STAFF RECOMMENDATION

1114 Calvin Avenue

April 15, 2015

Application: New construction—infill; Setback determination

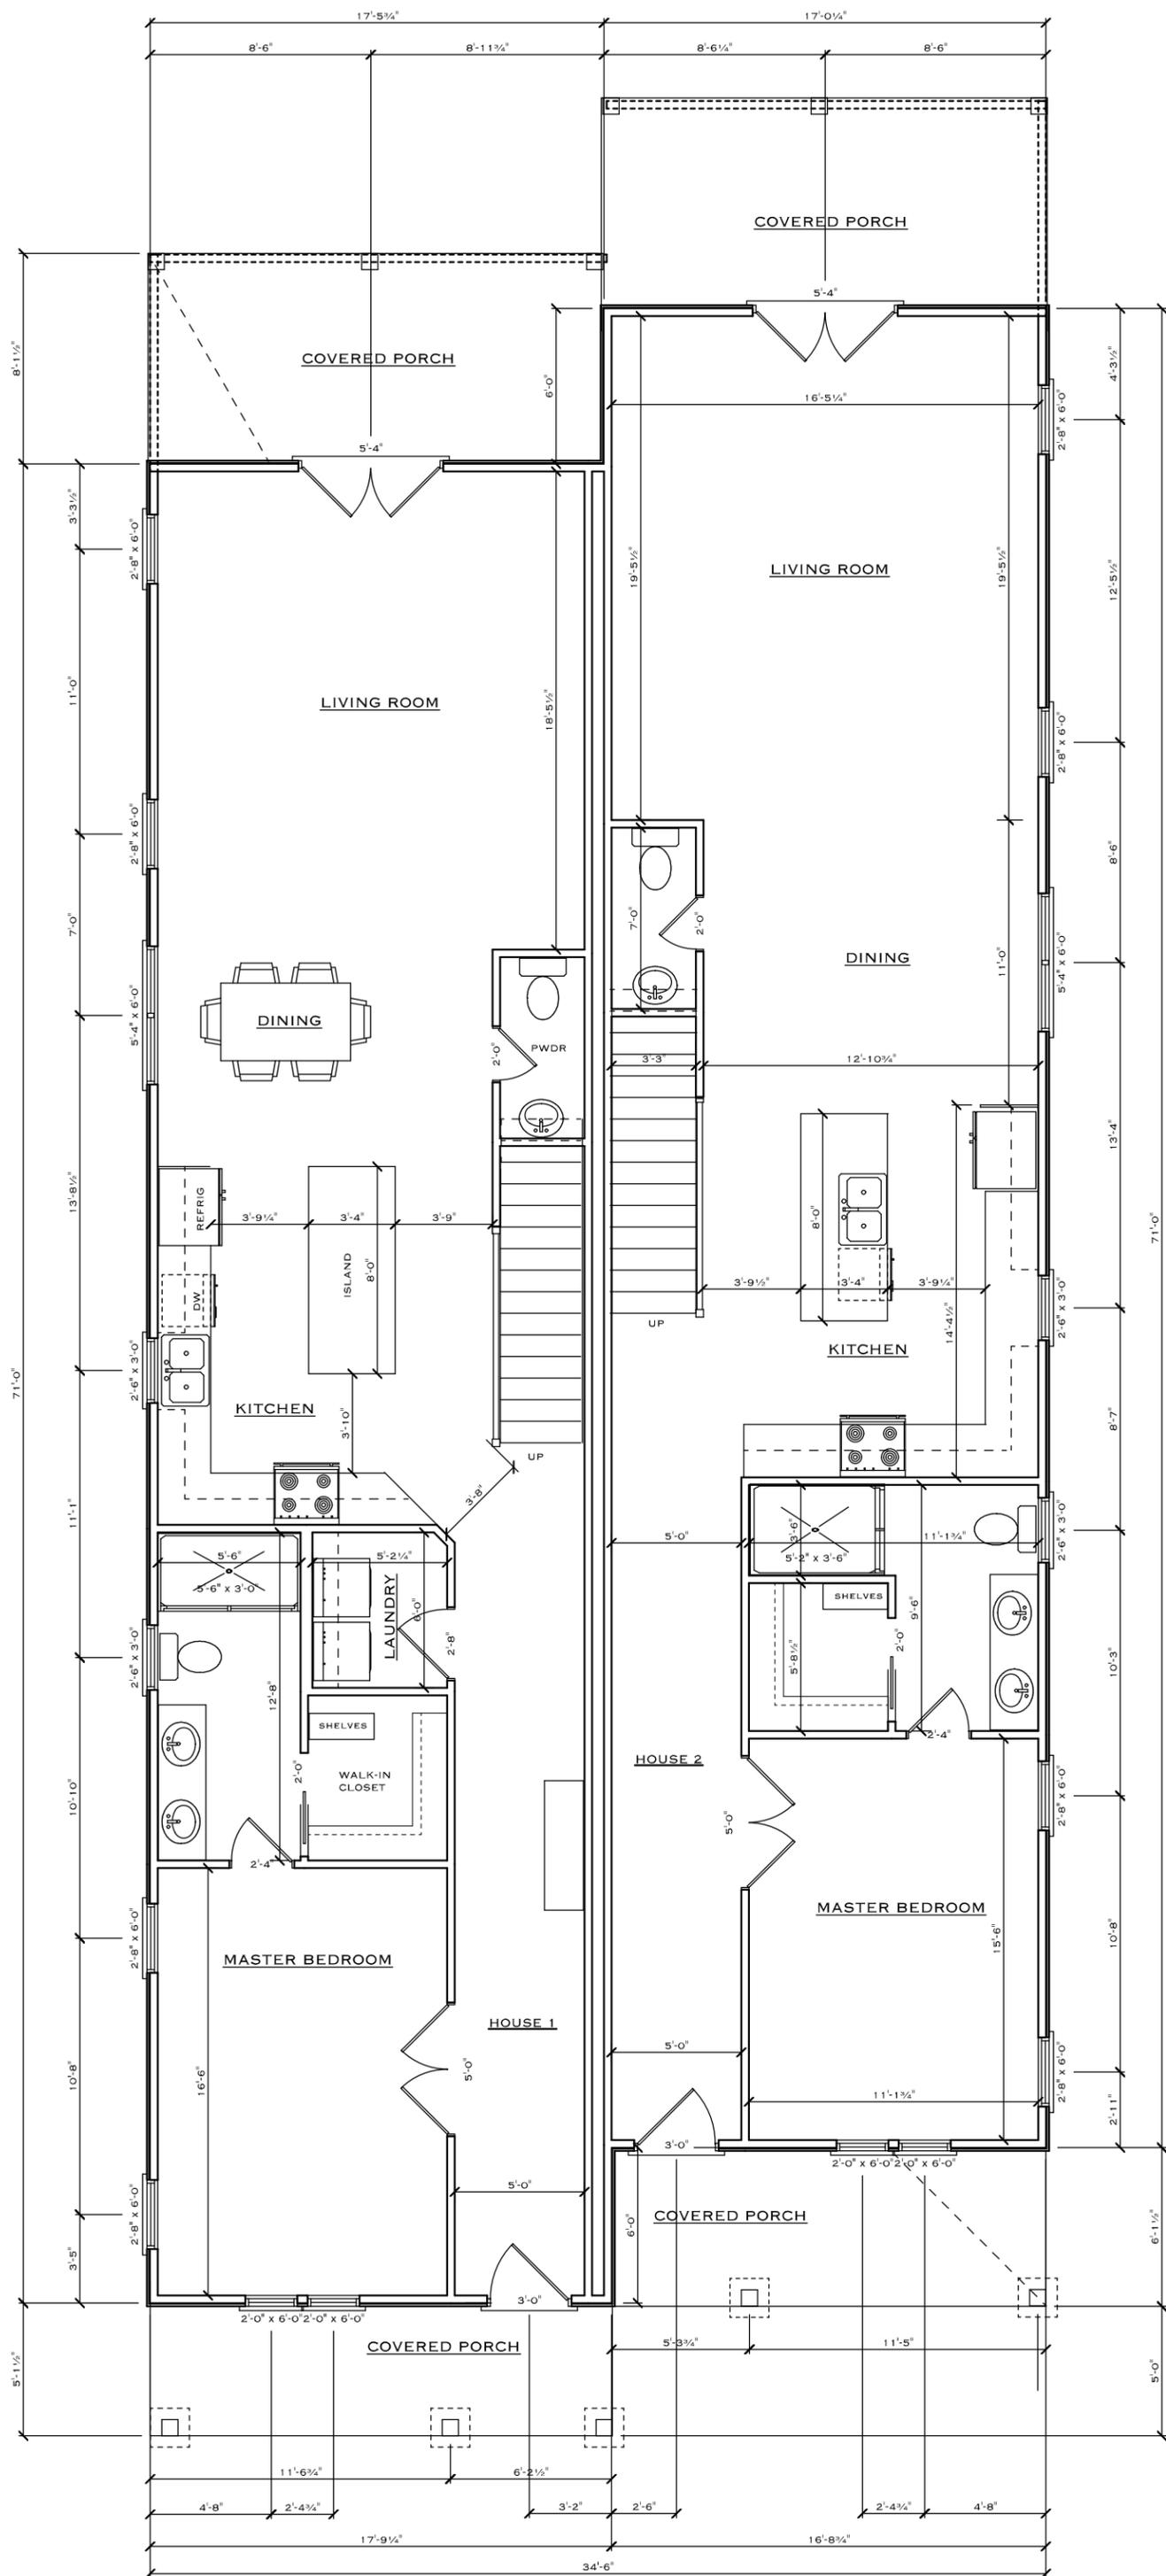
The house will be five feet (5') from the interior side property line. The infill will be set back approximately thirty-six feet (36') from the front property line, matching the front setback of the historic house to the west. Staff notes that the submitted site plan does not have the actual footprint of the proposed house, and does not show the footprints of the neighboring properties. Staff asks that a condition of approval be that the applicant submit a revised site plan with this information on it. With this condition, staff finds that the infill's setback and rhythm of spacing meet Section II.B.1.3. of the design guidelines.

3. The applicant submit a revised site plan showing the accurate footprint of the house and the footprints of the neighboring houses;
4. The side dormers be inset a minimum of two feet (2') from the wall below;
5. Staff approve the roof color, a masonry sample for the front porch columns, any front porch railing, and the materials of any walkways/driveways ;
6. Staff approve the final details, dimensions and materials of windows and doors prior to purchase and installation;
7. The front porches be a minimum of six feet (6') deep;
8. The new curb cut be single lane and no more than twelve feet (12') wide;
9. Concrete walkways be added leading from Calvin Street to the front entries; and,
10. The HVAC shall be located behind the house or on either side, beyond the mid-point of the house.

LEFT SIDE ELEVATION - 12TH STREET

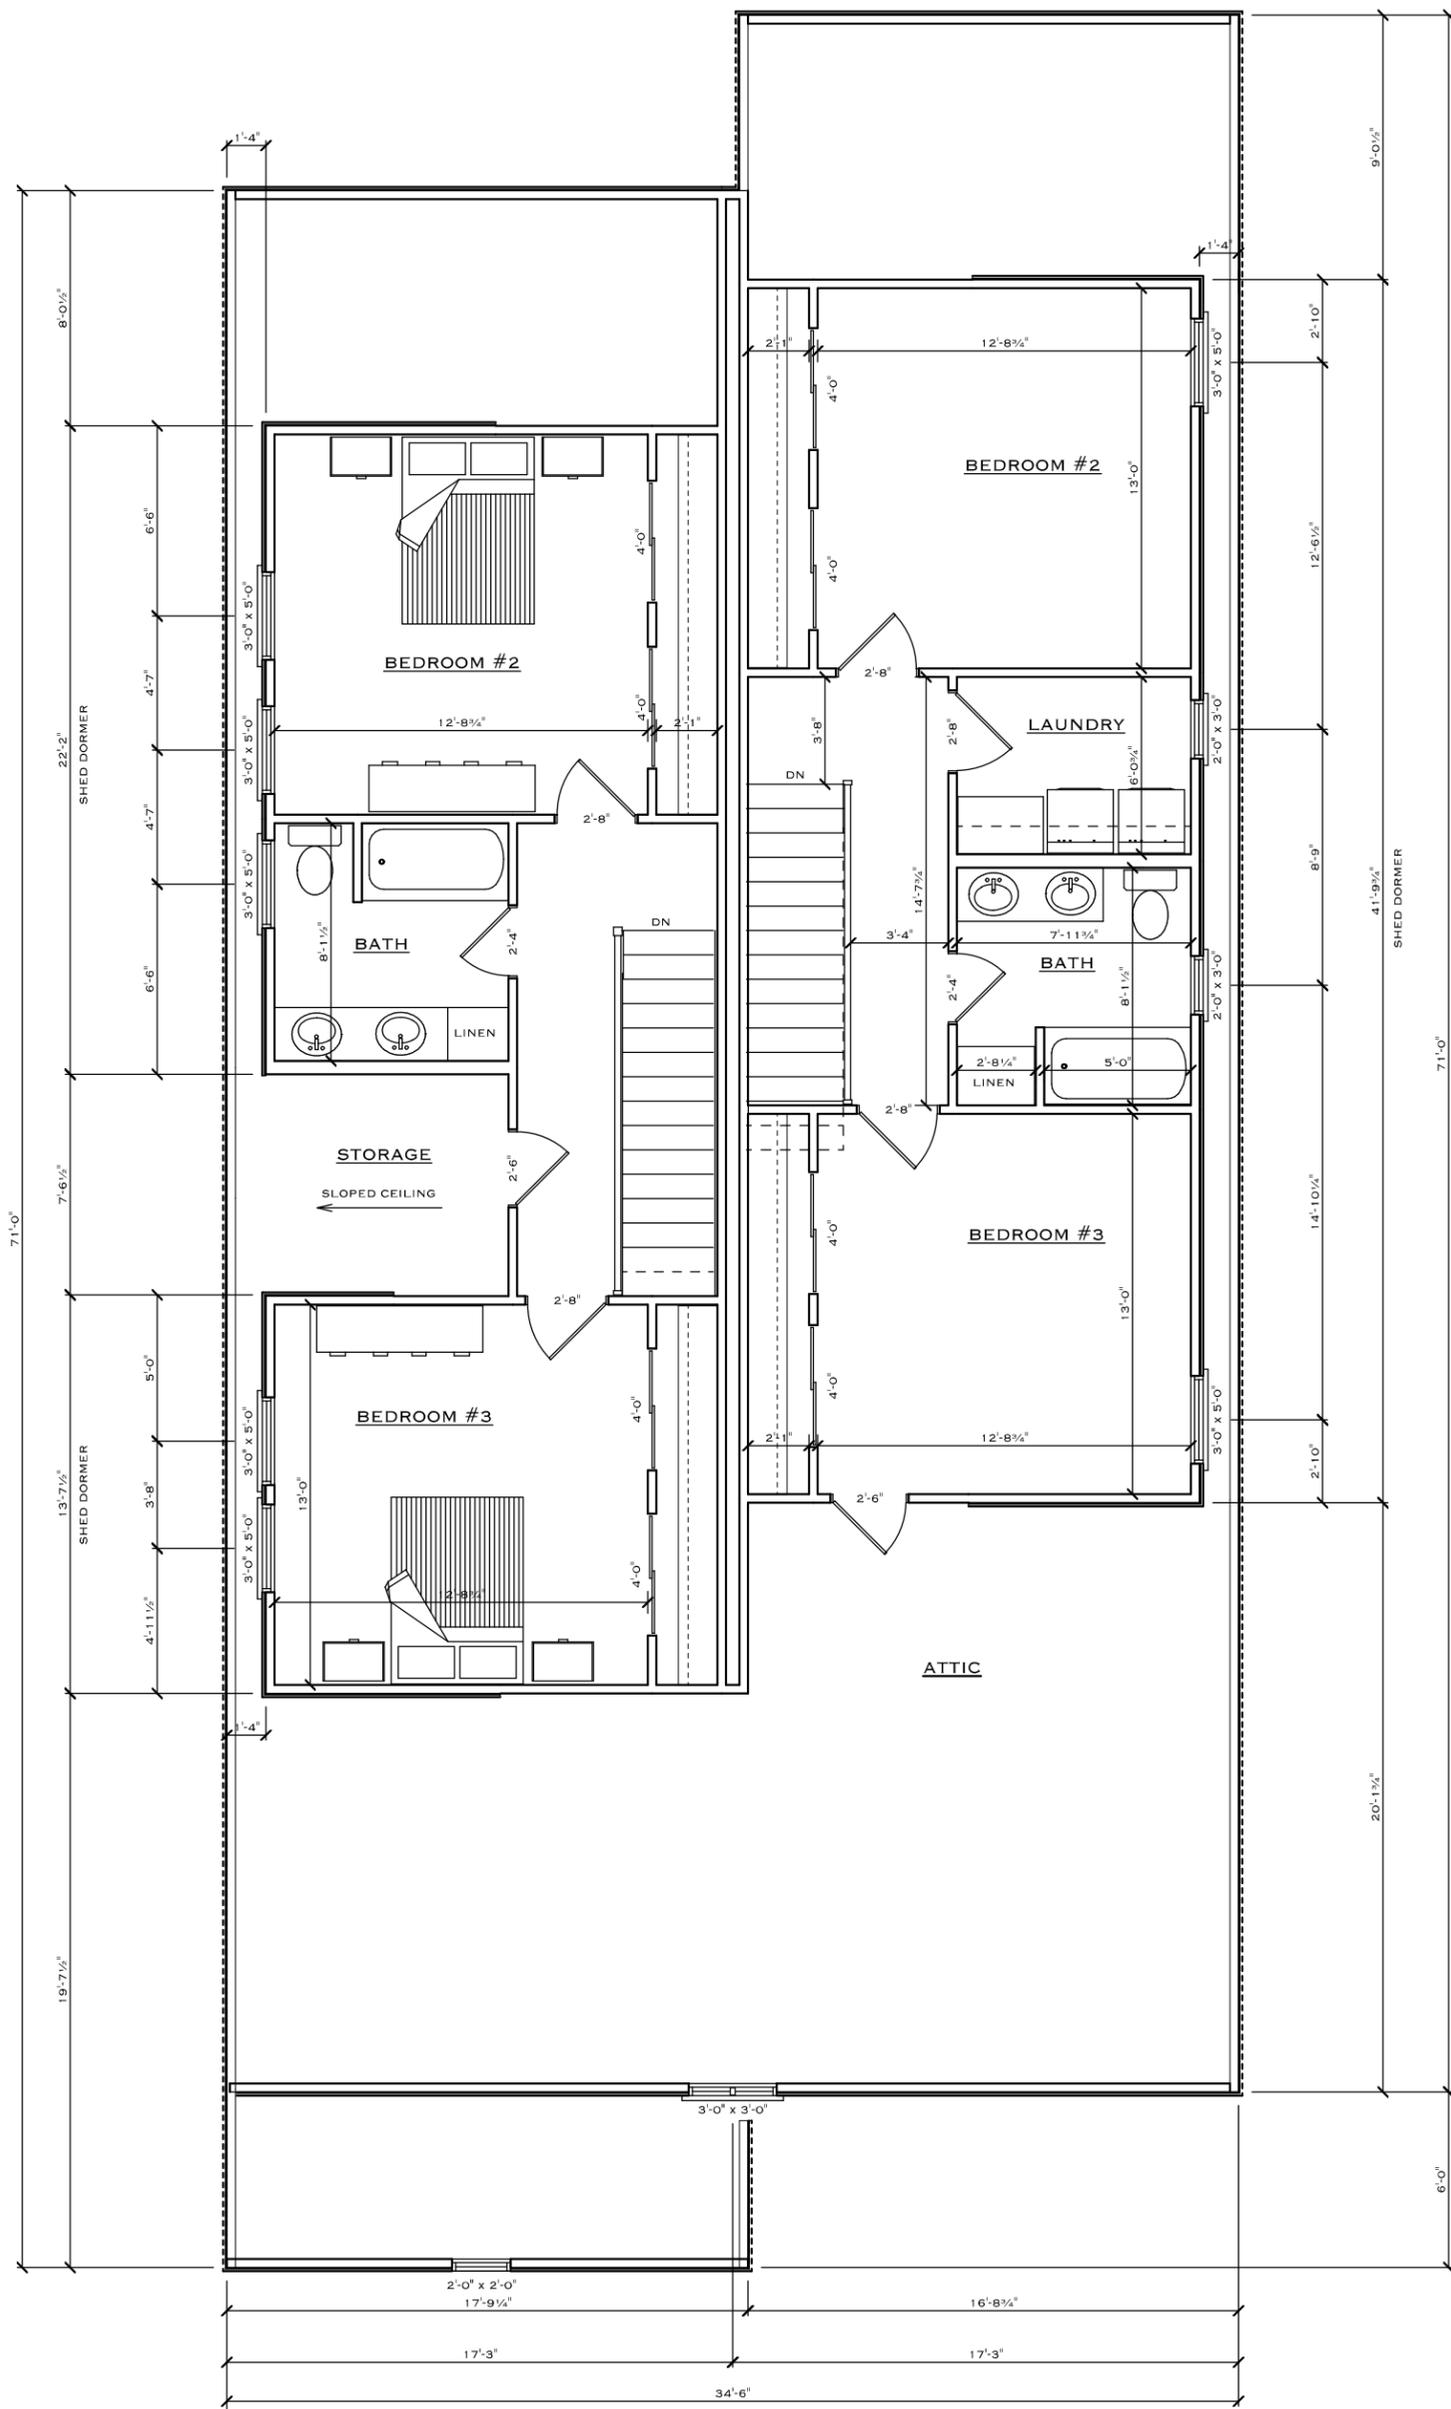
Because this is a corner lot, the left/east side façade will be highly visible on North 12th Street. The seventy-one foot (71') expanse of wall space on North 12th Street is longer than what is typically found on corner lots, and in the past, the Commission has asked applicants to break up long façades like this one with an architectural element like a bay or inset. Staff asks that a condition of approval be that the applicant break up the left/east façade with a bay or other significant architectural feature like an inset. With this condition, staff finds that the infill's height and scale meet Sections II.B.1 and II.B.2. of the design guidelines.

Setback & Rhythm of Spacing: As proposed, the infill meets all base zoning setbacks. It will be located slightly off center on the lot in order to meet the required ten foot (10') side setback on the North 12th Street side. MHZC staff is recommending that the applicant construct a bay to break up the North 12th Street facade. This bay would require a setback determination so that it could intrude eighteen to twenty-four (18"-24") into the ten foot (10') side setback. Staff is therefore asking the Commission to require a bay on the east/left façade and issue a setback determination.

Roof Shape: The roof will be a front-facing gable with a 10:12 pitch. The side dormers each have shed roofs with 3:12 pitches. The dormers are set off the ridge by two feet (2') but are only set back from the wall below by one foot, four inches (1'4"). Staff asks that the dormers be set off the wall below by two feet (2') to lessen the impact of their massing, as seen from the street. With the additional dormer inset, staff finds that the proposal meets Section II.B.5. of the design guidelines.

Orientation: The duplex is oriented towards Calvin Street, and both entrances face Calvin. The duplex will have two separate porches. The porch and entrance for the eastern/left unit will be behind a one-story projecting gable. The porch for this unit is only five feet, one inch (5'1") deep, and staff asks that it be a minimum of six feet (6') deep. The porch for the western/right unit is six feet (6') deep.

1. The finished floor height shall be consistent with the finished floor heights of the adjacent historic houses, to be verified by MHZC staff in the field;
2. The left/east façade be broken up with a bay or a significant architectural feature like an inset;
